Event Bulletin 01 - Technical

Micro Max UK – Mini Max 950

5.8 Carburettor

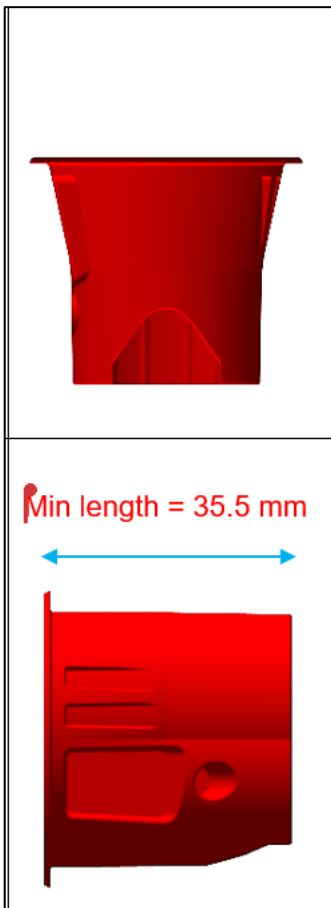
Clarifications listed in red in the table/photo below.

ROTAX part number: 267536. No modifications are allowed, the ribbed surface on the inlet is to help ensure dimensions have not been modified.

Please note the new measurement of 35.5mm as listed below.
